RELEASE FOR CONSTRUCTION
AS NOTED FOR PLAN REVIEW
DEVELOPMENT SERVICES
LEE'S SUMMIT, MISSOURI
02/05/2024

REVISIONS		
NO.	DATE	DESCRIPTION
1		MARK UP SET revision: 02.05.24
2		
3		
4

TWIN SIENNA
FARMHOUSE
OSAGE #77

A1.0

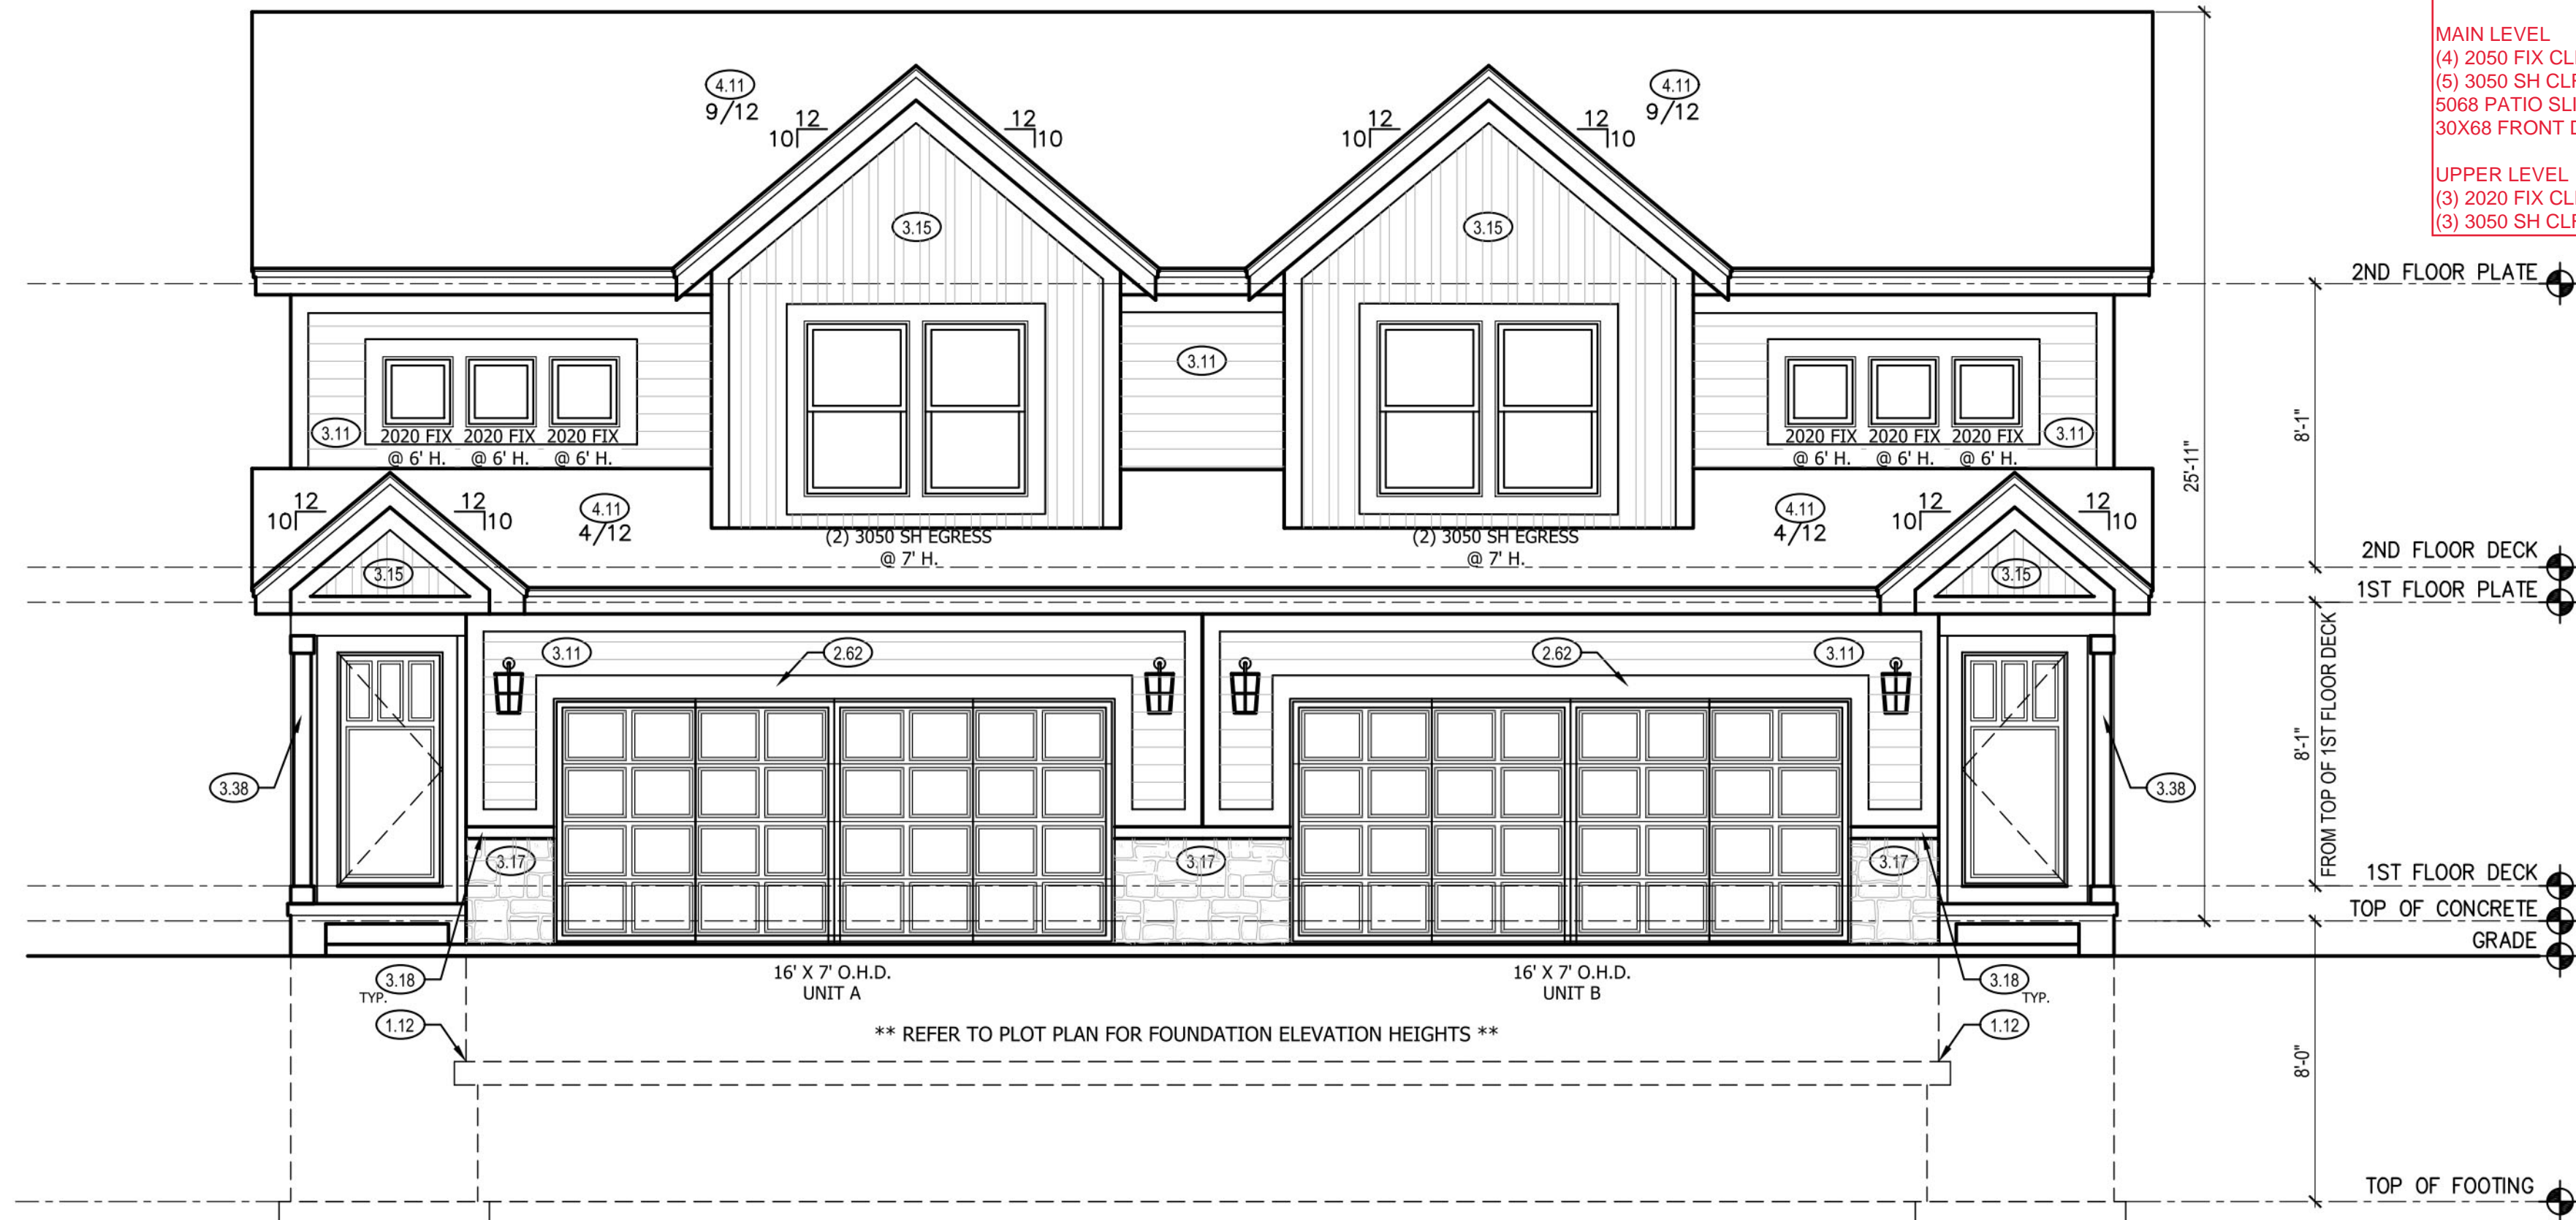
R602.3.2 TOP PLATE. EXCEPTION:
..... THE TOP PLATE MAY BE OMITTED
OVER LINTELS THAT ARE ADEQUATELY
TIED TO ADJACENT WALL SECTIONS WITH
STEEL PLATES OR EQUIVALENT.....

A3.0

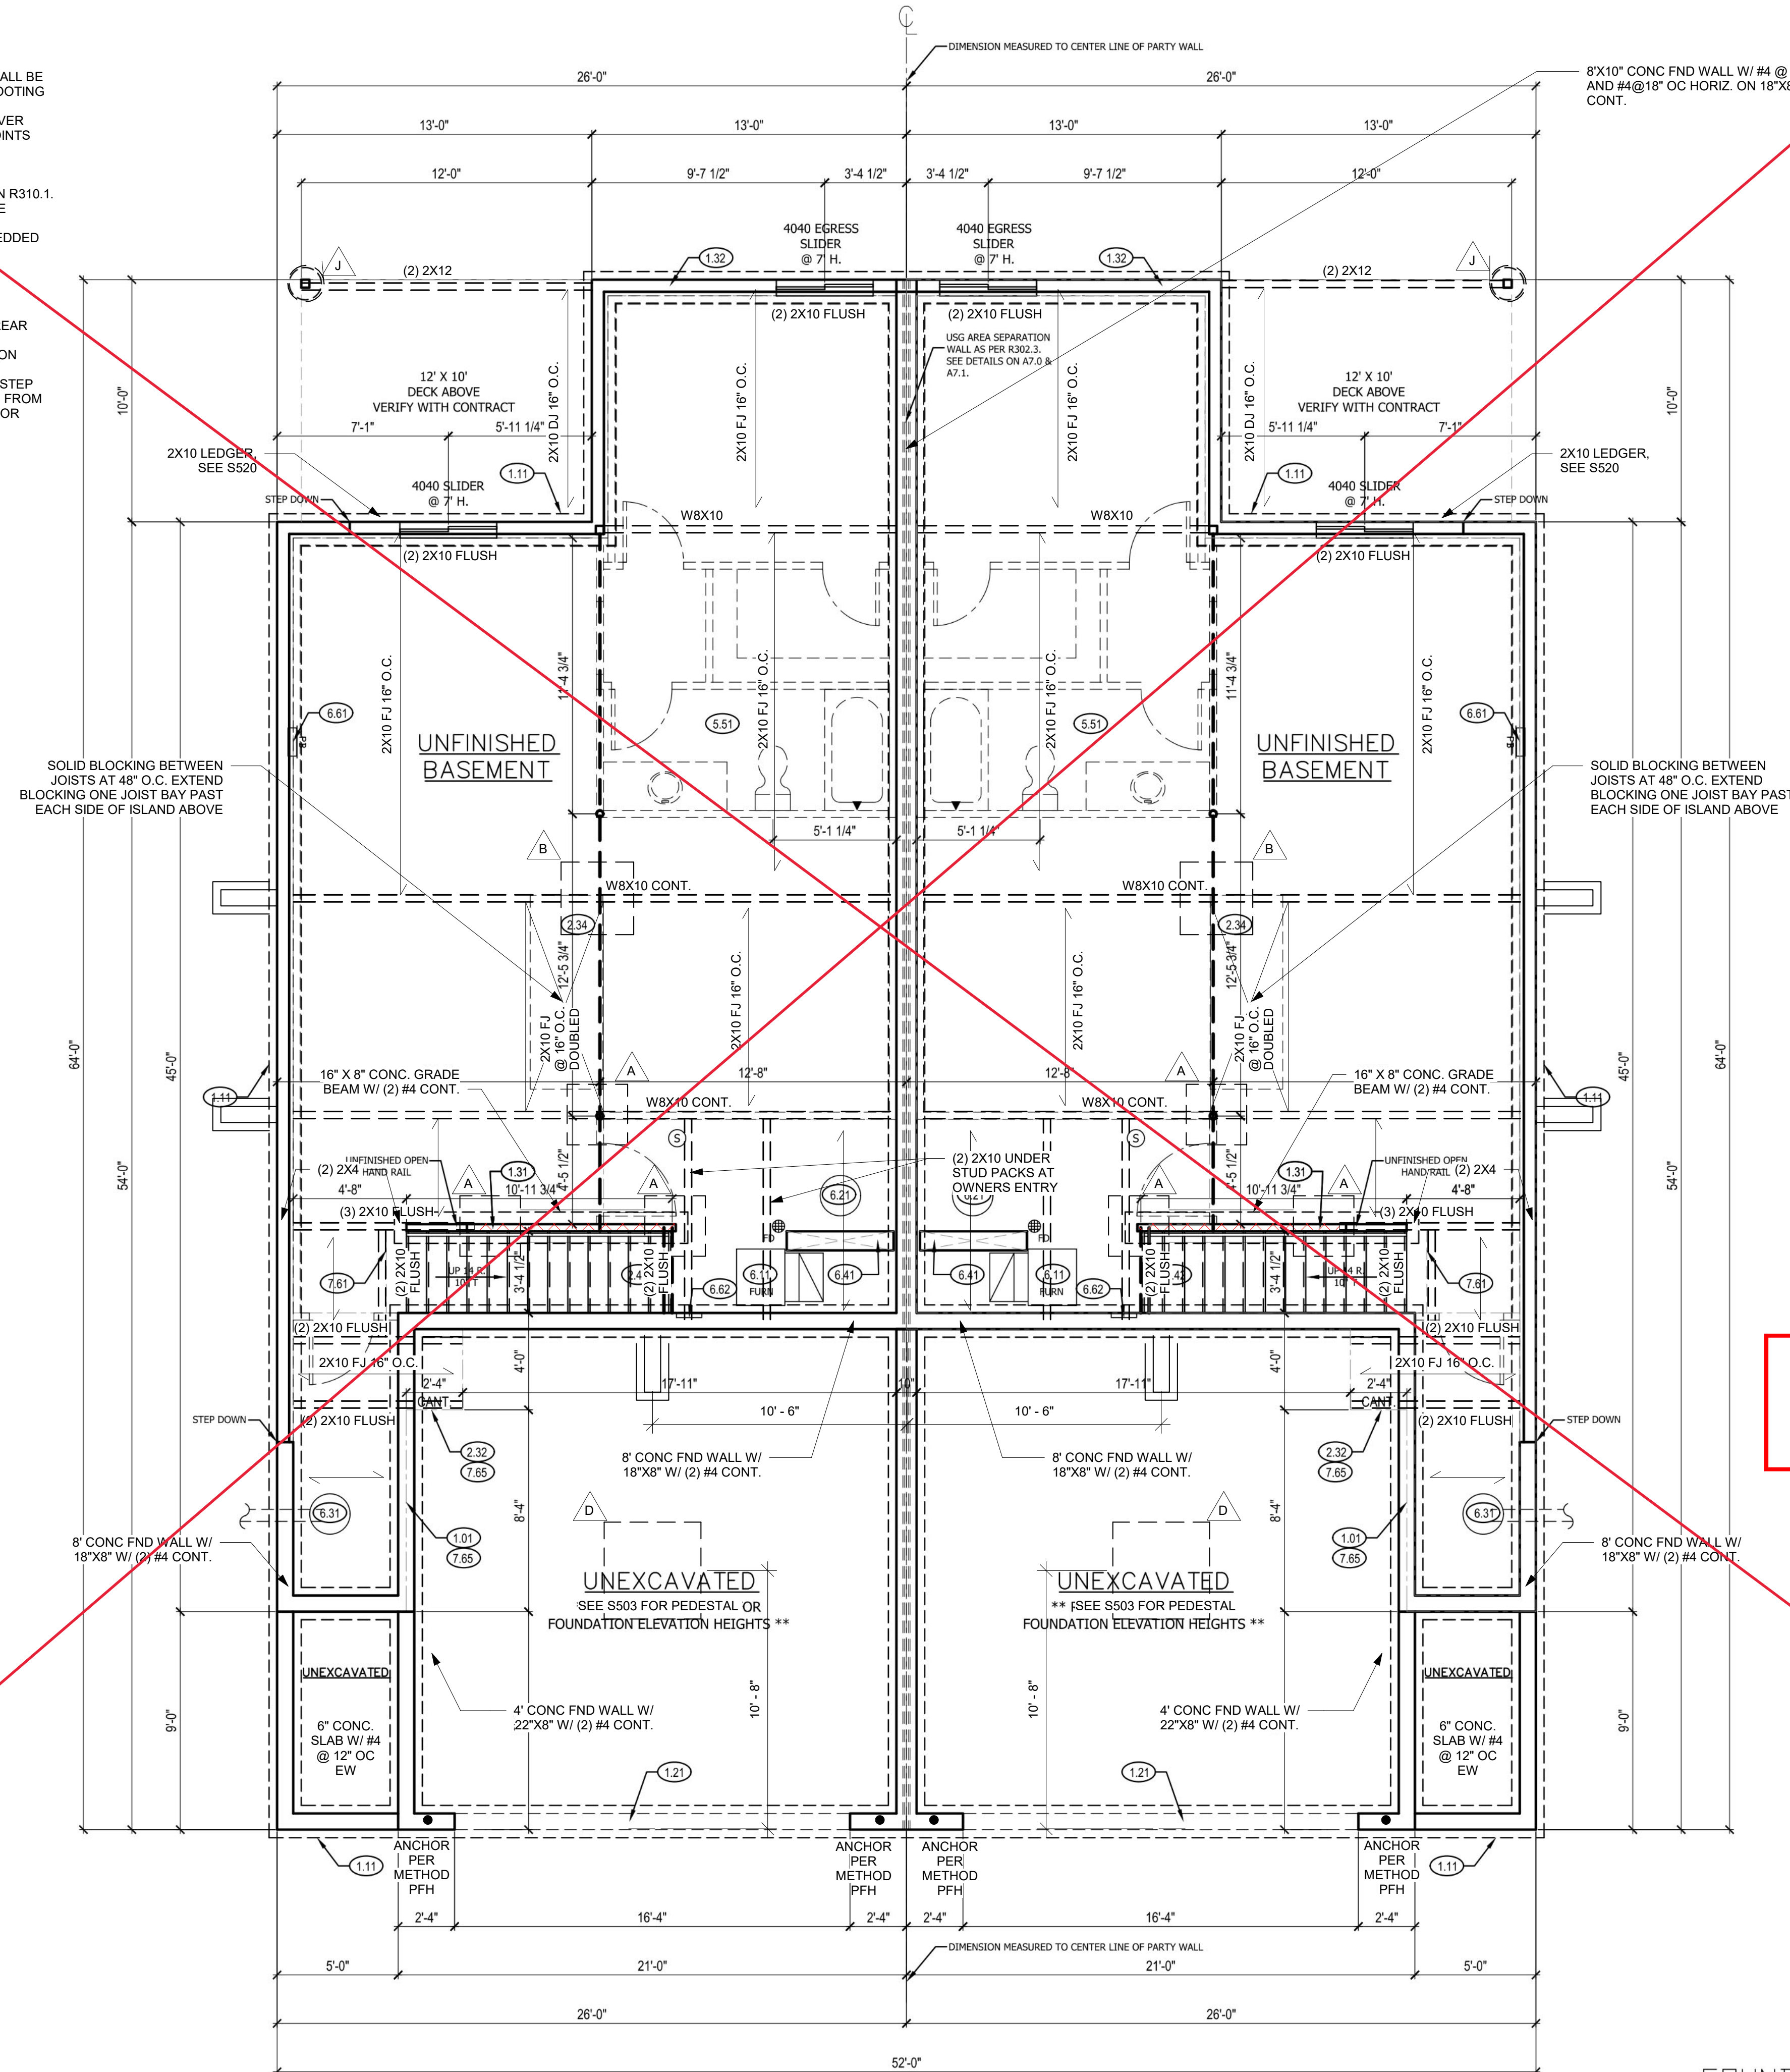
USE OTHER A3 PAGE THAT
SHOWS CORRECT BEAMS AND
BEAM SIZES
